51 JOYCE ROAD
EASTCHESTER, NEW YORKDWG. TITLE:
AS-BUILT FIRST FLOOR PLAN
WITH PROPOSED CHANGESDavid A. Barbuti
Architect, PC150 White Plains Road
Suite 103
Tarrytown, NY 10591
Tel : 914-909-5143
Fax : 914-909-5144

PROJECT NAME:
AS-BUILT DRAWINGS FOR:
THE STRICKER RESIDENCE
51 JOYCE ROAD
EASTCHESTER, NEW YORK

DWG. TITLE:
**AS-BUILT SECOND FLOOR AND ROOF
PLANS WITH PROPOSED CHANGES**

DWG. TITLE:
AS-BUILT ELEVATIONS
WITH PROPOSED CHANGES

AS BUILT REAR ELEVATION (WITH PROPOSED CHANGES)

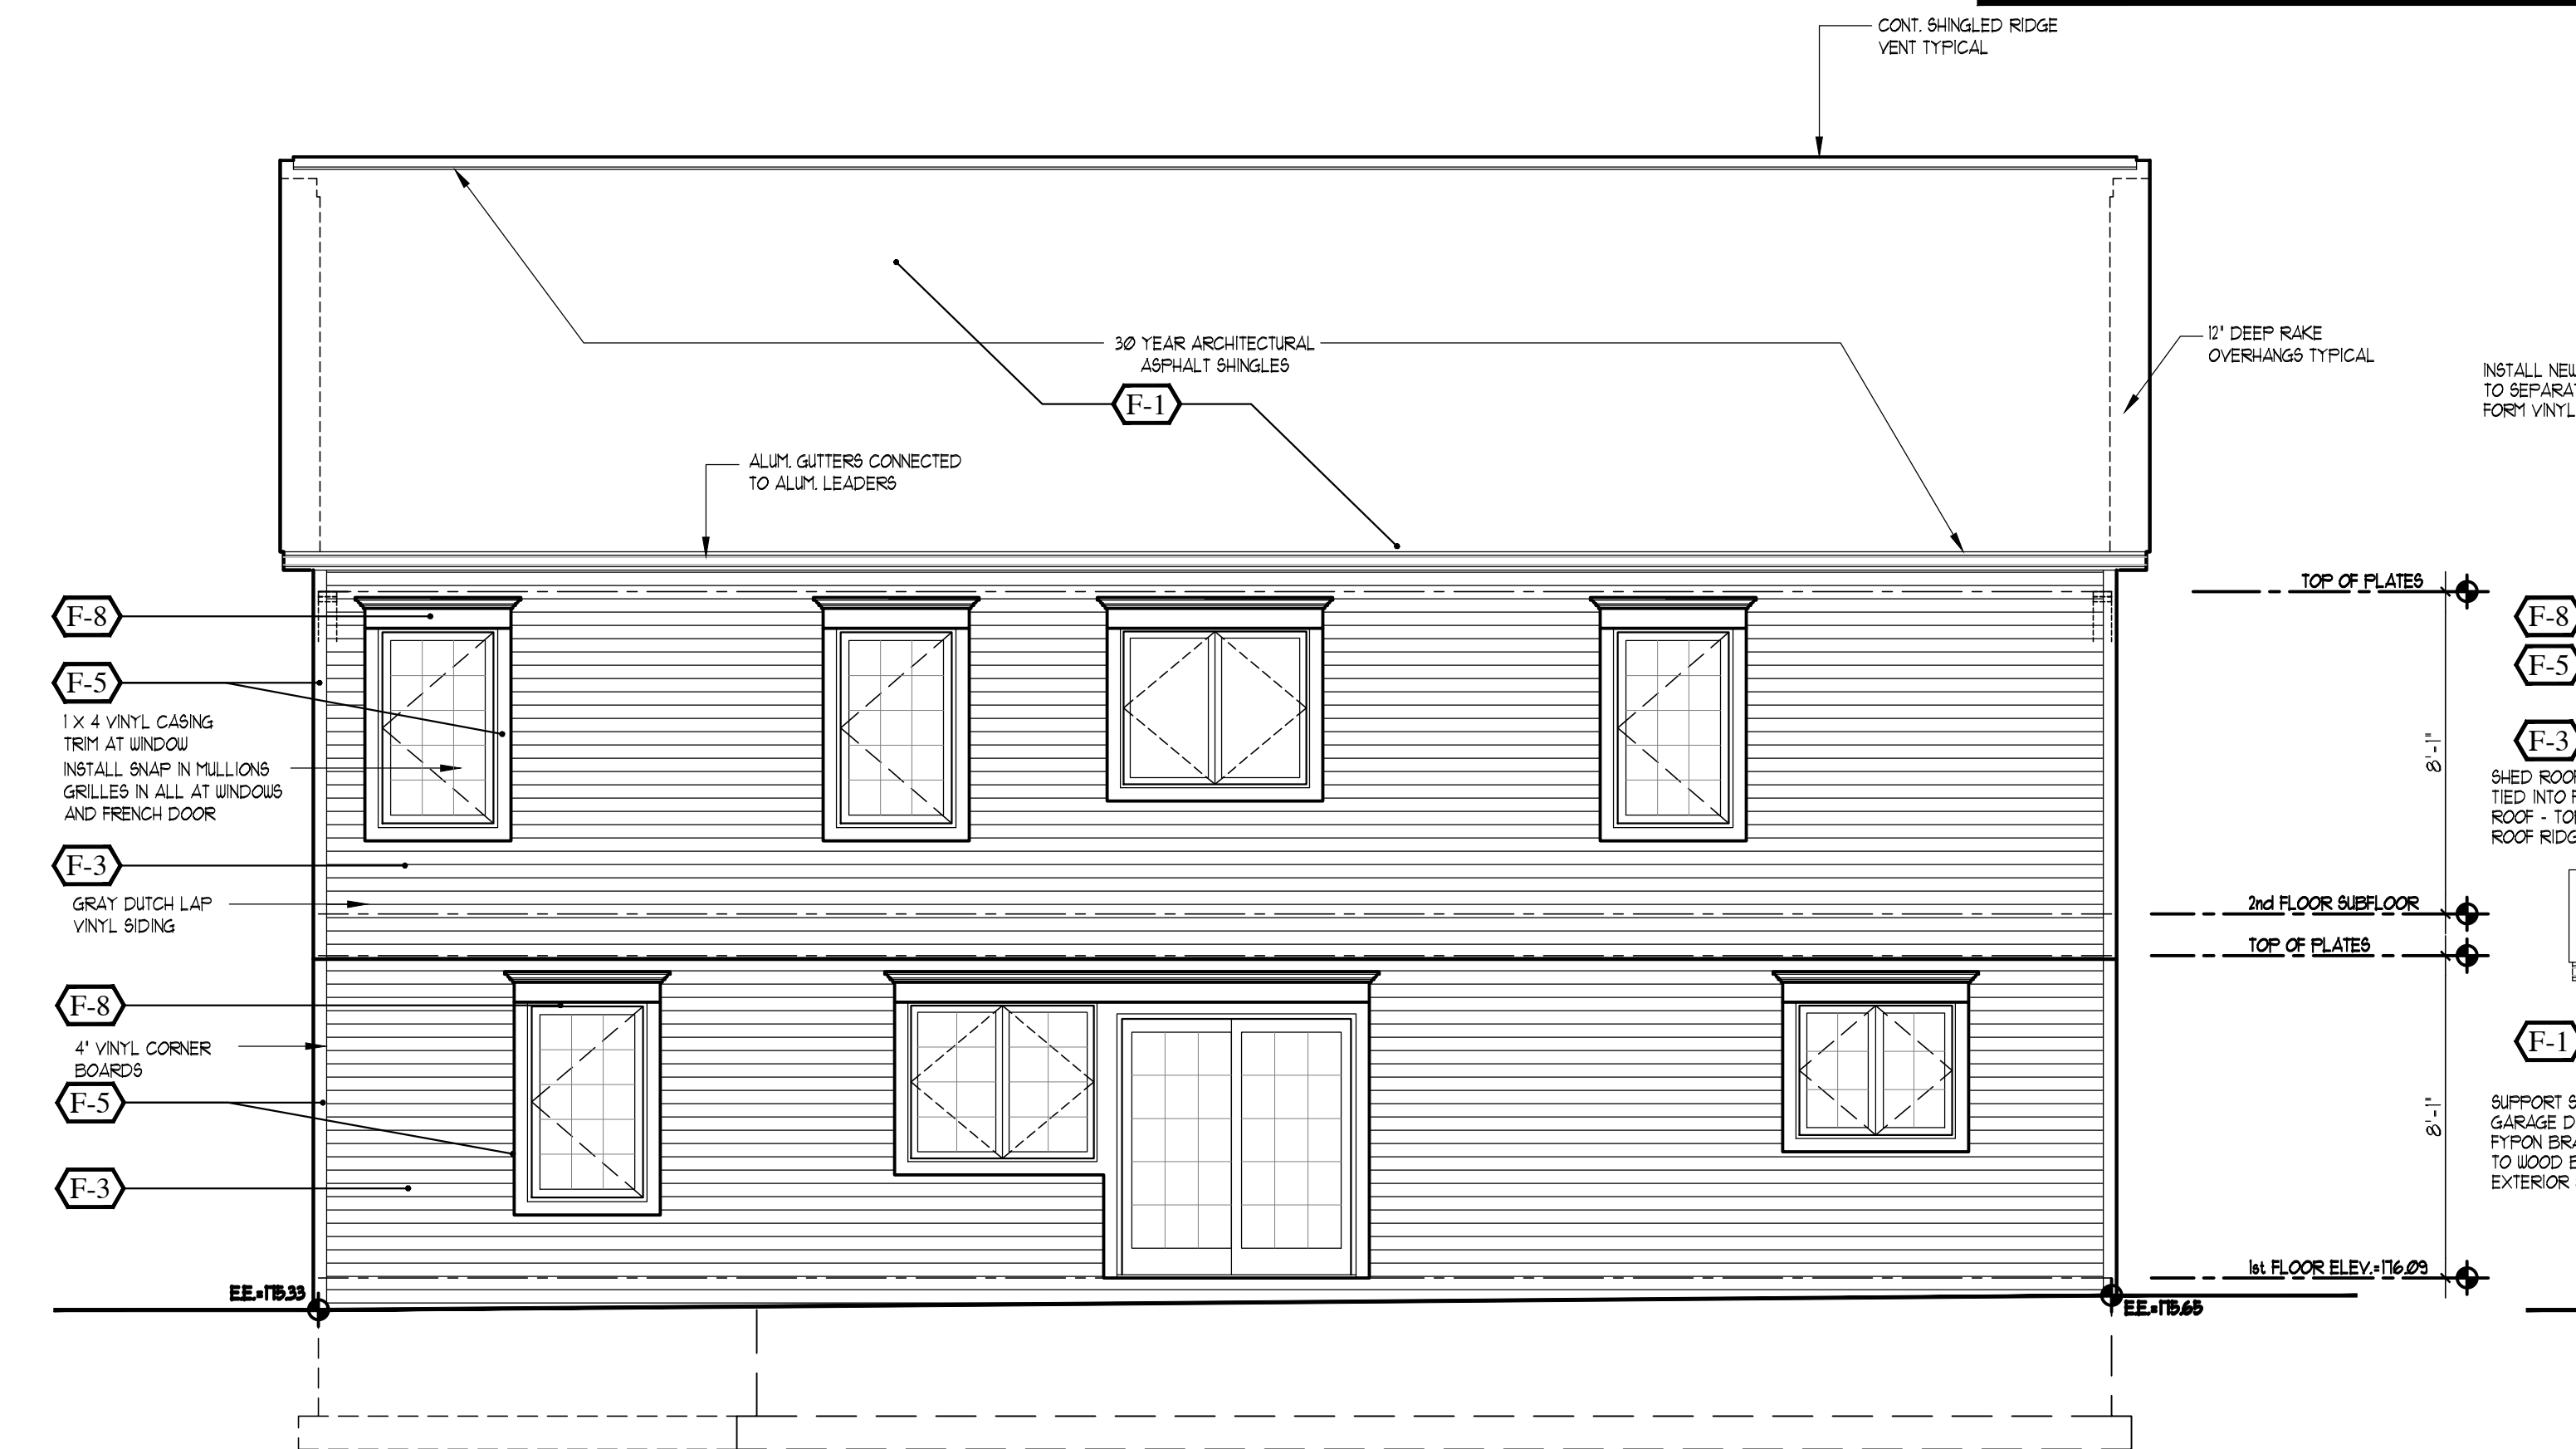
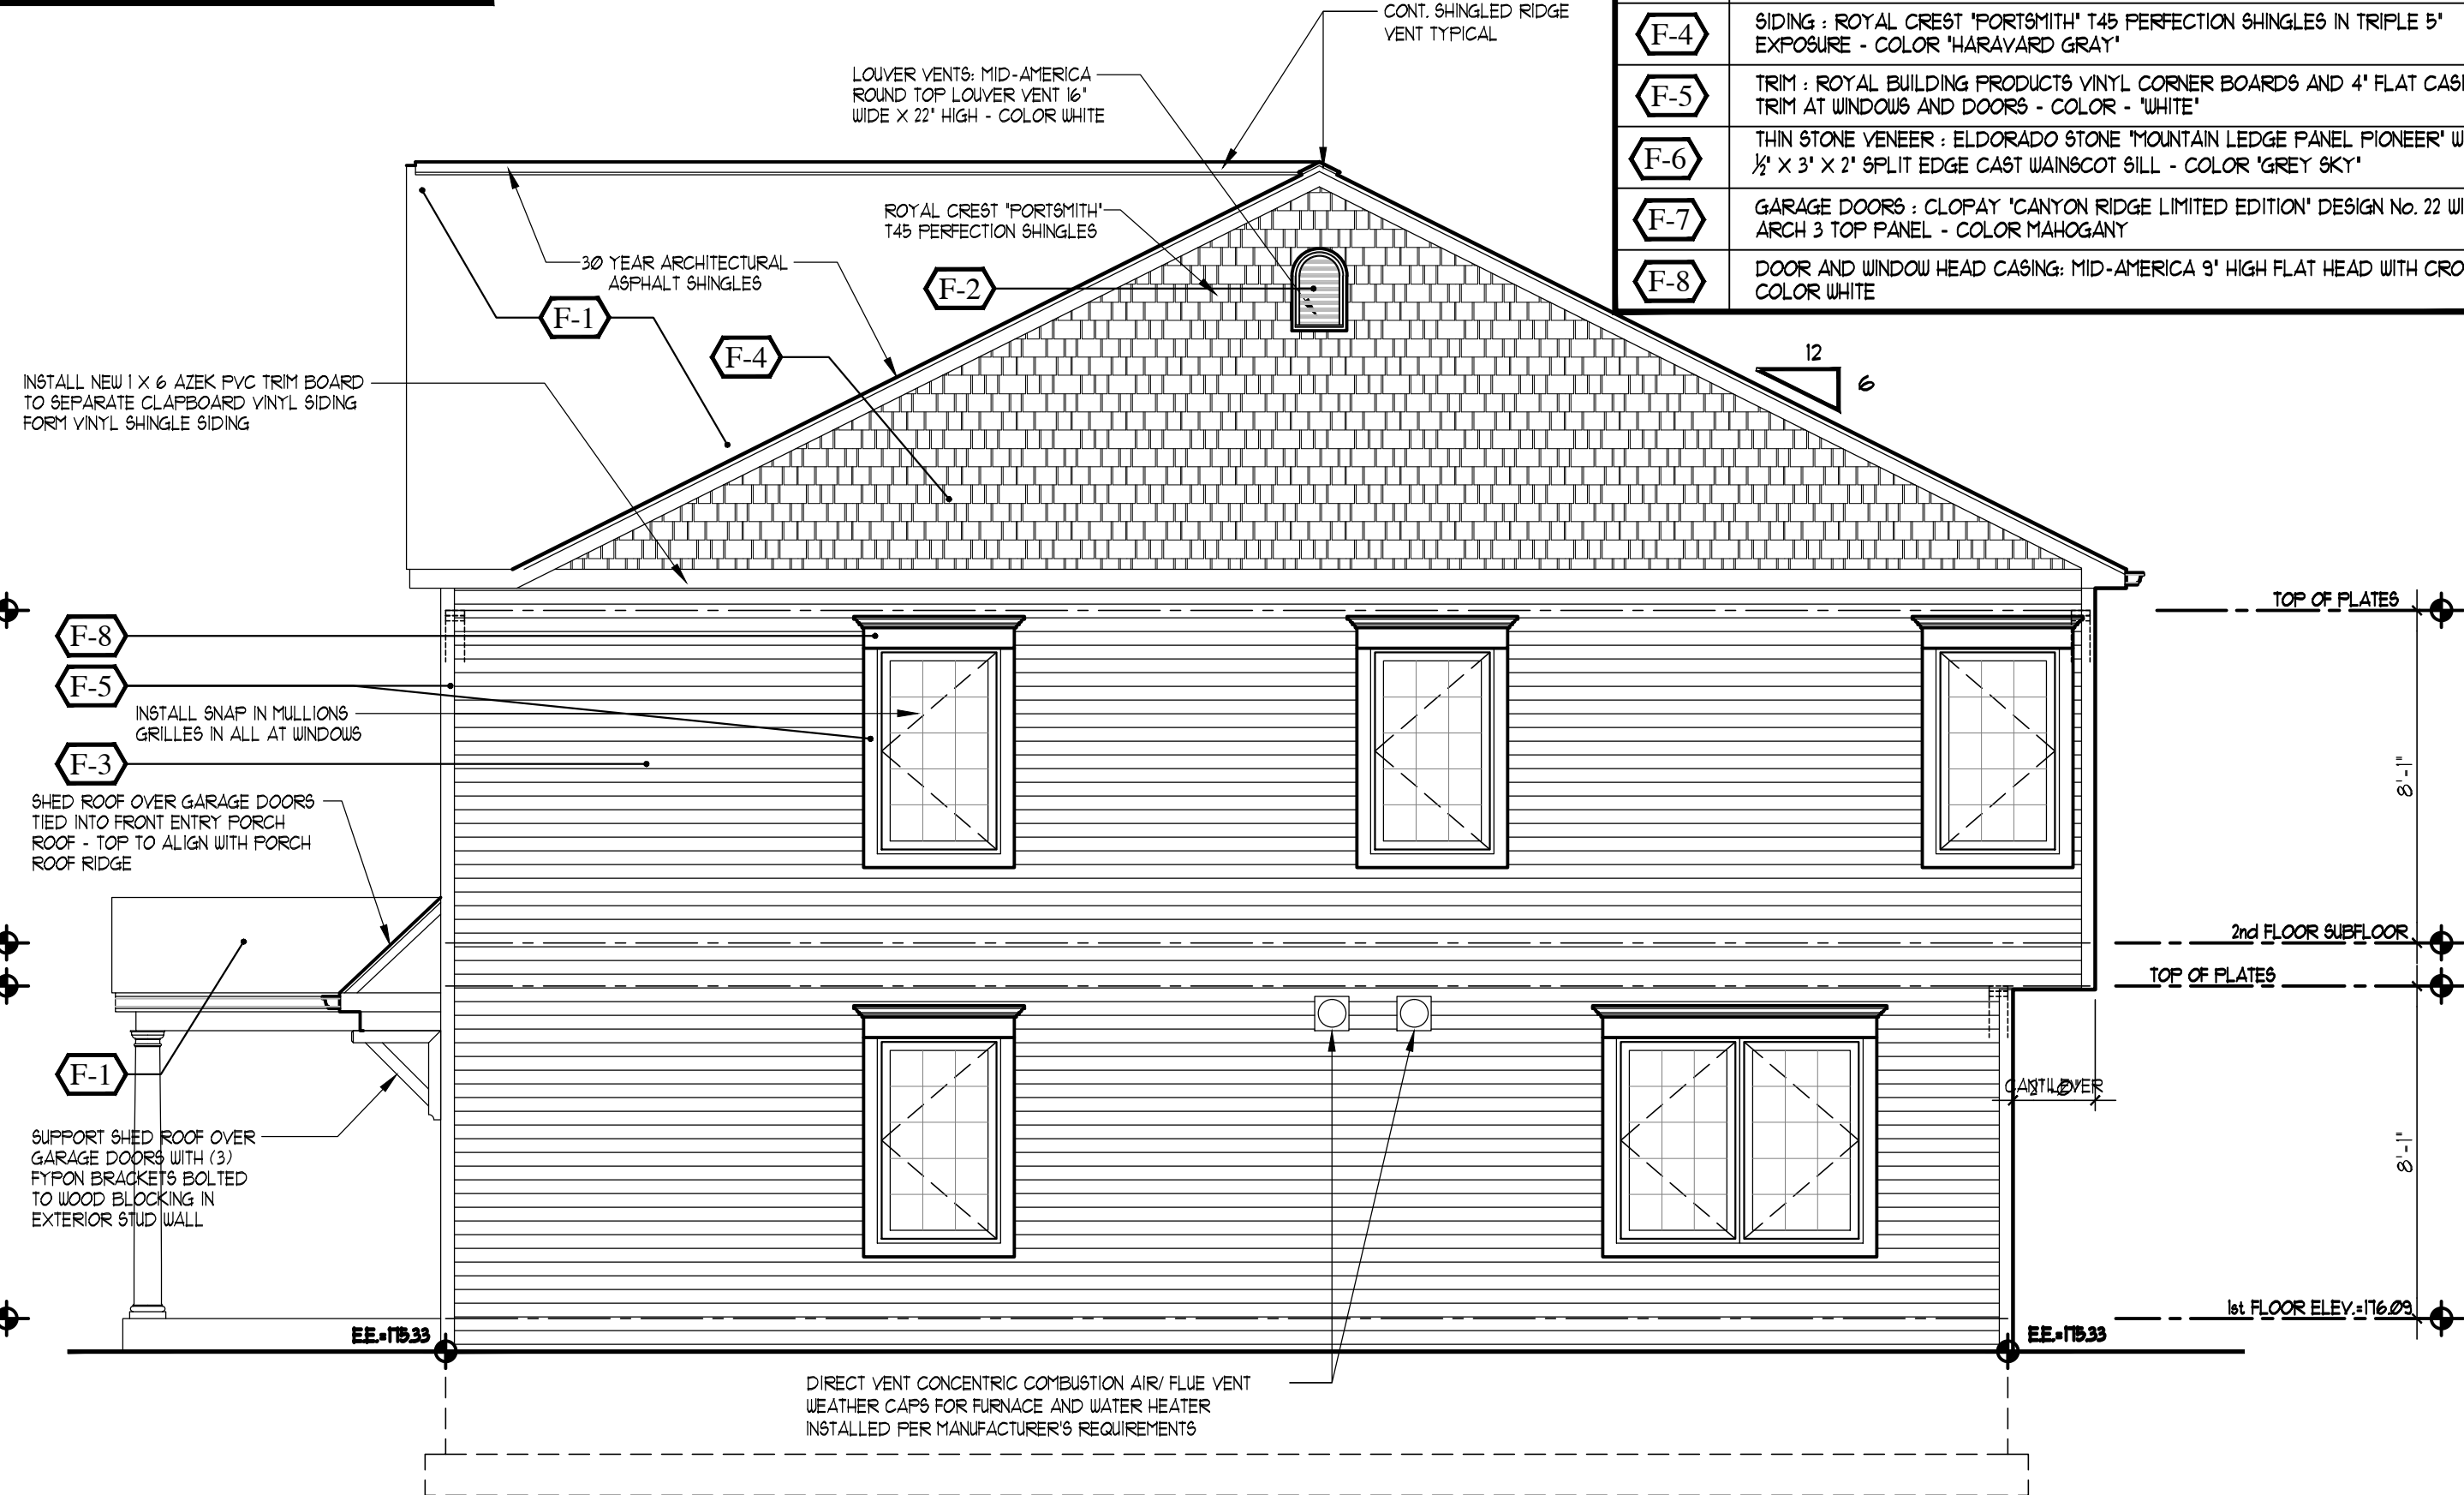
ADDED WINDOW & DOOR CASING & HEAD TRIM. REVISED LARGE PICTURE WINDOW'S GRILLE PATTERN. REVISED GARAGE DOOR STYLE TO REFLECT THE ACTUAL DOORS CHANGES REQUESTED BY ABB FOR APPROVAL.	11-27-19	C.P.	DATE	DESCRIPTION
REVISED FLOOR PLANS AND ELEVATIONS TO REVISED FLOOR PLANS AND ELEVATIONS TO SHOW AS-BUILT CONDITIONS AND PROPOSED CHANGES TO GET NEW ABB APPROVAL.	10-21-19	C.P.	DATE	DESCRIPTION
REVISED ELEVATIONS TO SHOW PROPOSED CHANGES REQUESTED BY ABB FOR APPROVAL.	11-27-19	C.P.	DATE	DESCRIPTION
REVISED FLOOR PLANS AND ELEVATIONS TO REVISED FLOOR PLANS AND ELEVATIONS TO SHOW AS-BUILT CONDITIONS AND PROPOSED CHANGES TO GET NEW ABB APPROVAL.	10-21-19	C.P.	DATE	DESCRIPTION
ADDED WINDOW & DOOR CASING & HEAD TRIM. REVISED LARGE PICTURE WINDOW'S GRILLE PATTERN. REVISED GARAGE DOOR STYLE TO REFLECT THE ACTUAL DOORS CHANGES REQUESTED BY ABB FOR APPROVAL.	11-27-19	C.P.	DATE	DESCRIPTION
